**RE: DA 2022/959/1**

**1-3 View Street CAMDEN**

*Construction of a 2 storey office premises including at grade car parking,  
landscaping and associated site works*

Source: *Dingo Partners Architectural Plans*

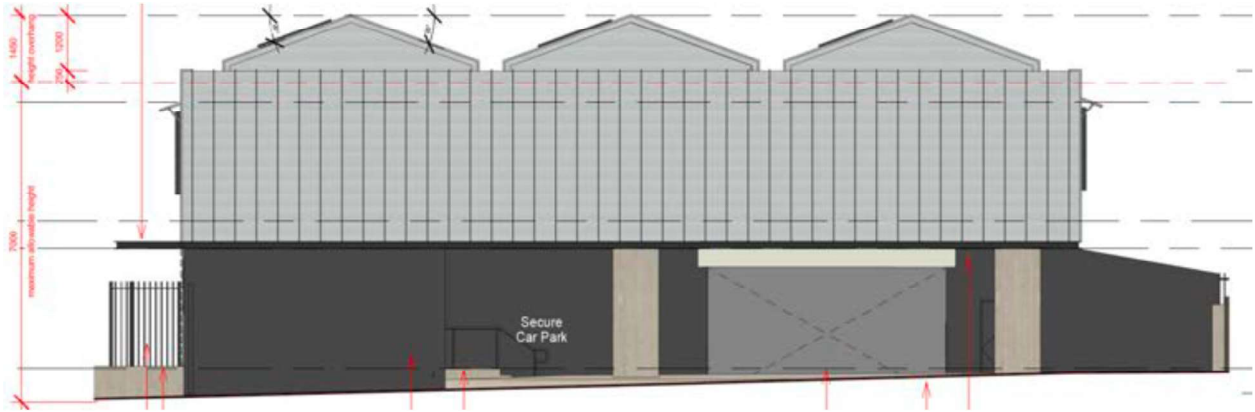
We appreciate the idea of the saw-tooth roofline and its potential resemblance to heritage roofscapes and the uniqueness of Camden’s HCA roofscape of smaller roof forms as expressed in the DCP (2.16.4). However, as shown in the architectural drawing above the shallow gables connect and sit oddly above a disproportionate boxlike structure that bears no resemblance to traditional architecture. The gable ends are also proposed to be comprised of glass with coverings of wooden slats which is completely different to a traditional roofline.
